March 26, 2025 MTC Commission Board meeting

Item 7a MTC Resolution No. 4537, Revised.

Major Project Advancement Policy: Stage Gate Evaluation and Recommendations for Transbay Joint Powers Authority - the Portal Project

2015 DTX draft SEIR

Recommendation #4

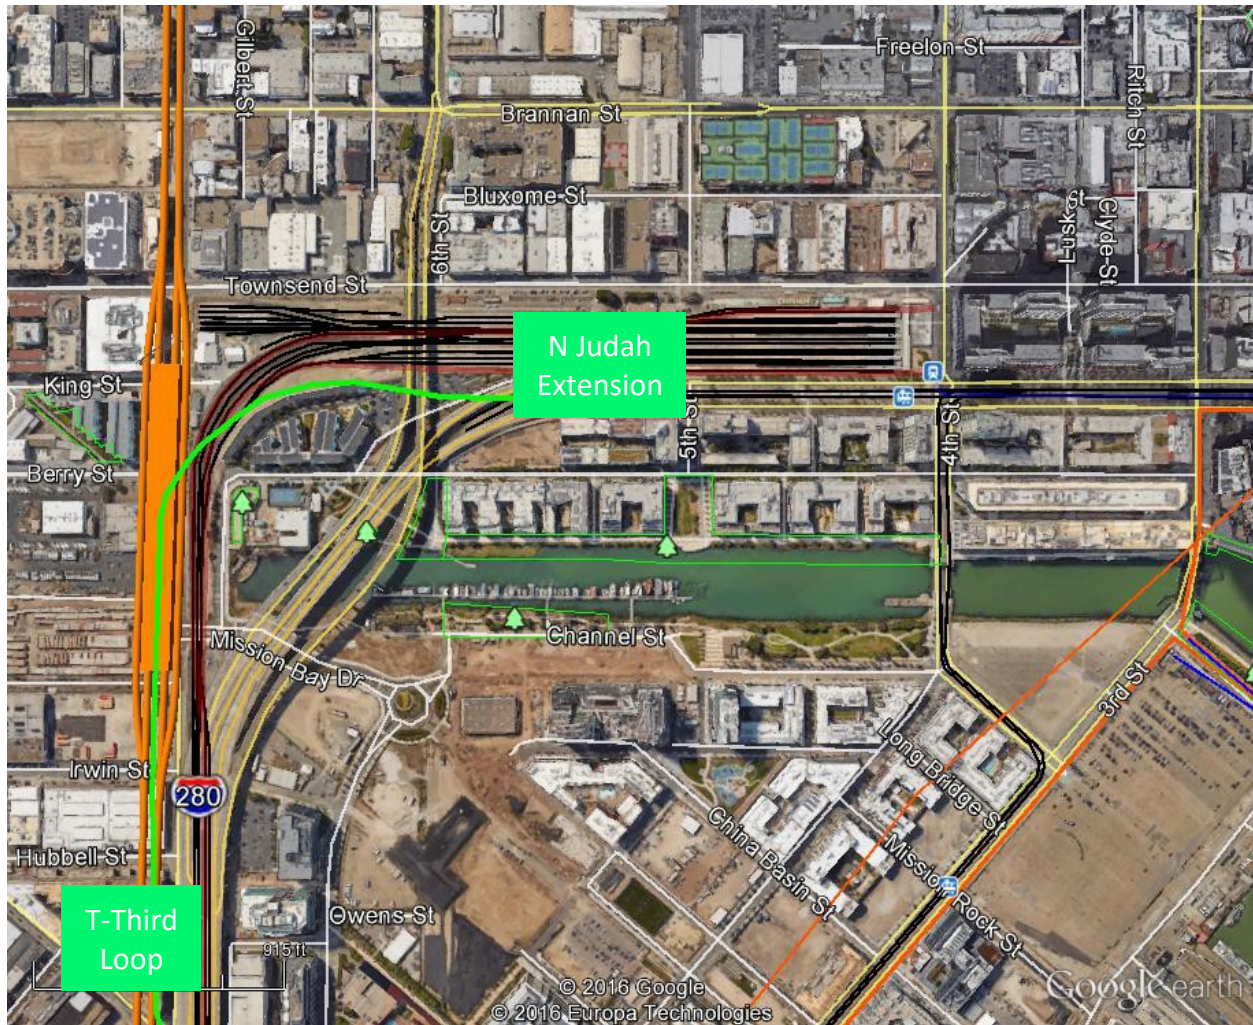
The SEIR should consider relocating the Townsend station to 7th Street and providing connectivity to the Central Subway via an extension of the N line connecting to the Mission Bay loop via 16th Street. This station should be designed to accommodate the Grand Boulevard at a later date.

5) 7th Street Tunnel Stub Box

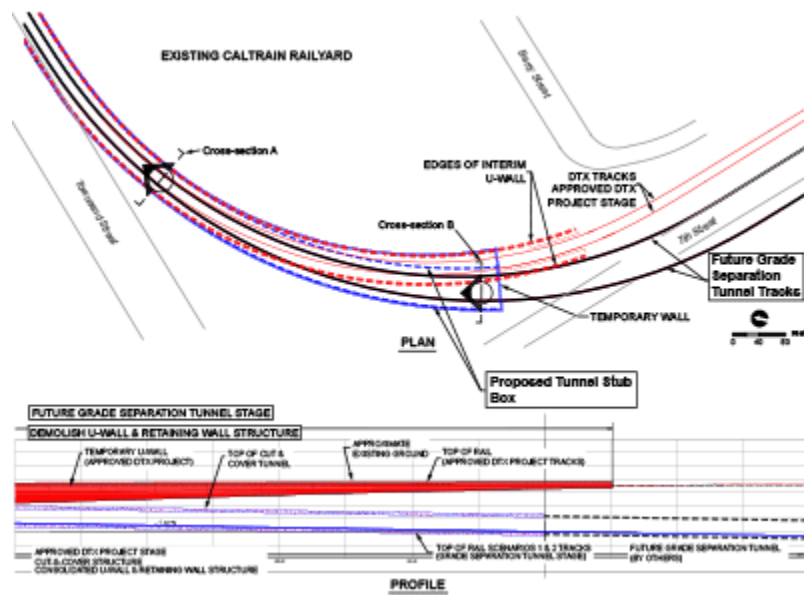
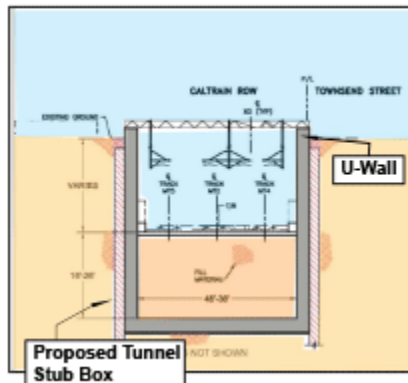
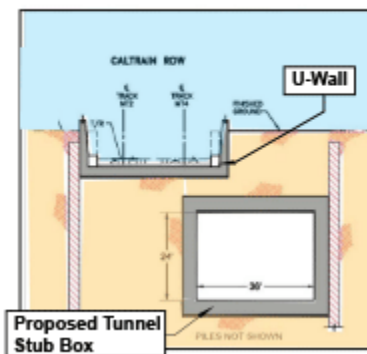
The SEIR proposes to terminate the DTX on 7th Street with a “tunnel stub box” designed to accommodate a future 16th Street grade separation.

Recommendation #5

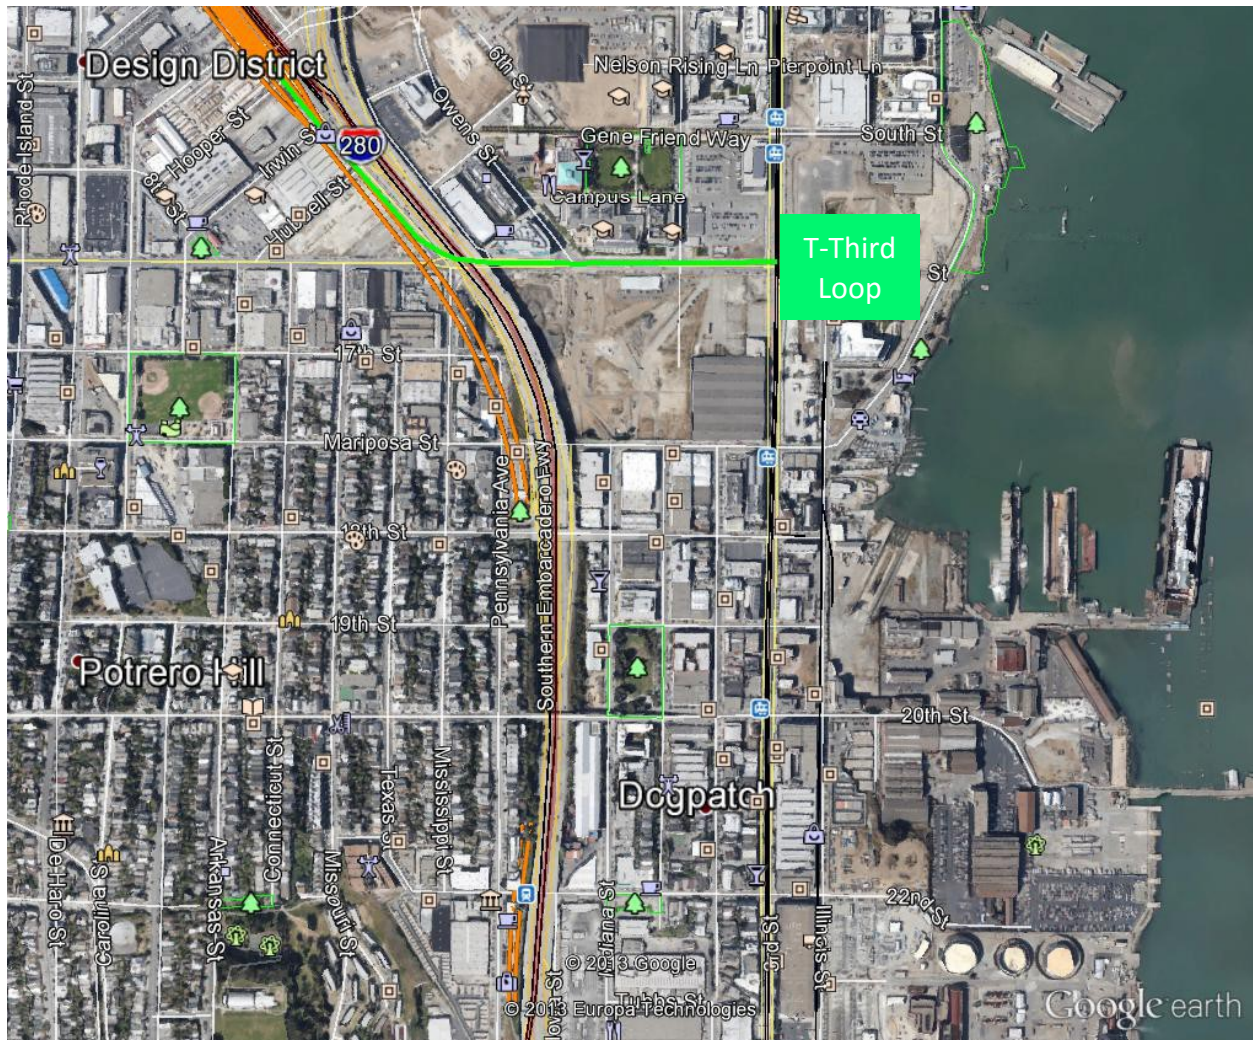
The SEIR should consider a direct connection to the Planning Department's Pennsylvania Avenue RAB study alternative. This would achieve 16th Street Grade separation as soon as Caltrain operations are relocated to the Transbay terminal and would save hundreds of millions by eliminating cut & cover structures @ 7th & Townsend

6) Turnback Track impacts on 16th Street grade crossing

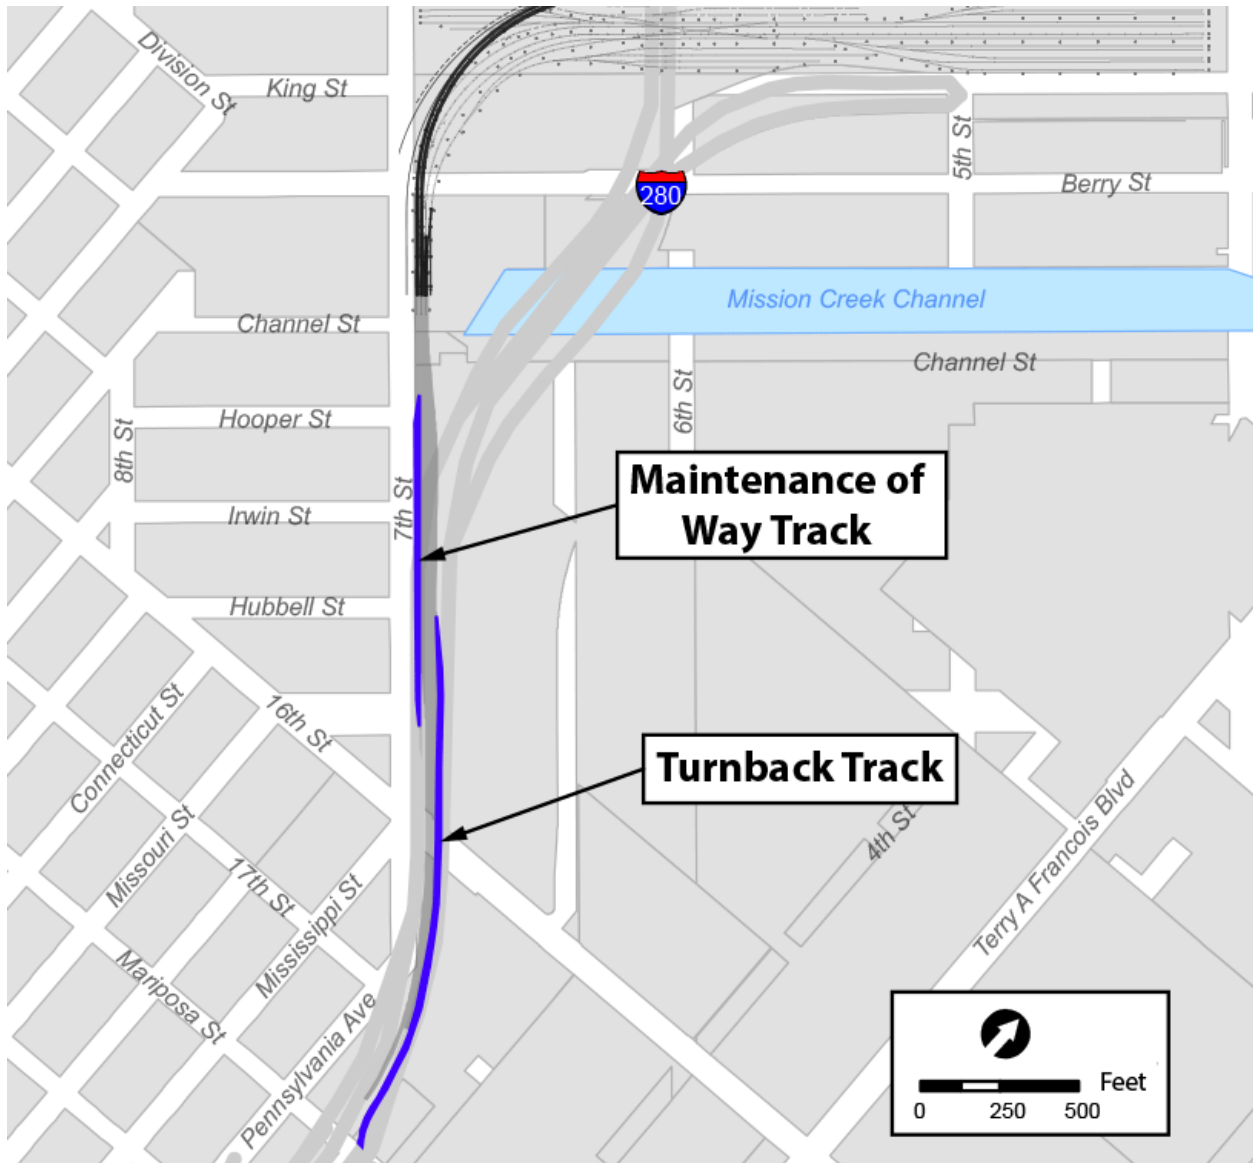
The SEIR proposes the addition of two additional tracks on 7th Street, including a turnback track across 16th Street, thereby increasing gate downtime for each train crossing by an additional 10 seconds (10 minutes per day).

The SEIR should consider a direct connection to the planning department's Pennsylvania Avenue alternative (see recommendation #5 above) and turn trains around further south. The SEIR should also consider the abandoned tunnel #1 for storage.

Recommendation #7

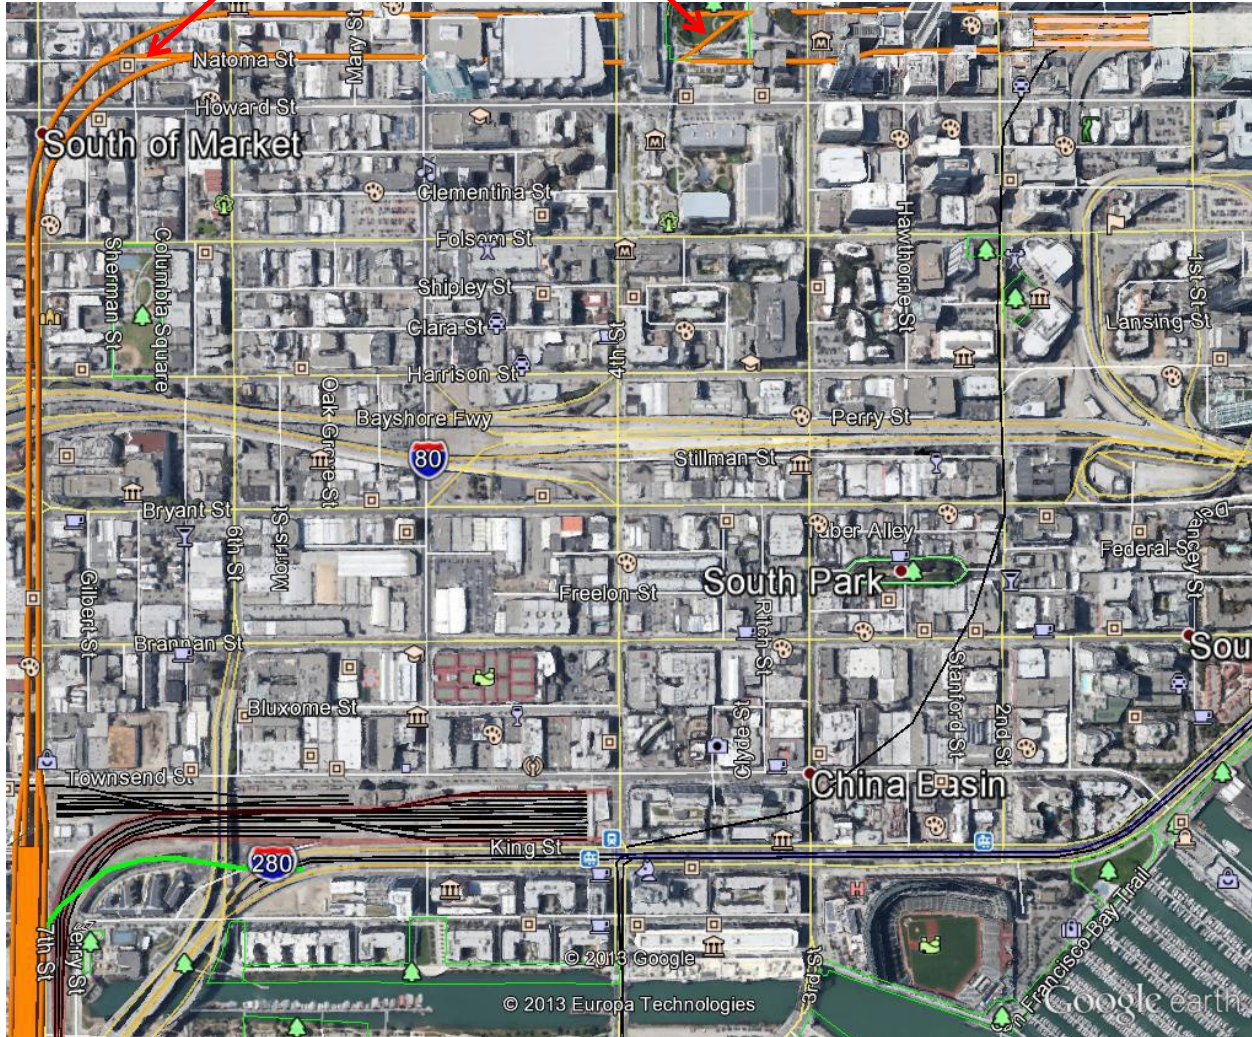
The current DTX alignment consists of 3 sharp curves each with a maximum speed of 25 MPH which extend the travel time between 7th Street and the Transbay Terminal by an additional 3 minutes.

The SEIR should consider an alternate alignment designed to enable an 80 MPH approach to the Transbay Transit Center.
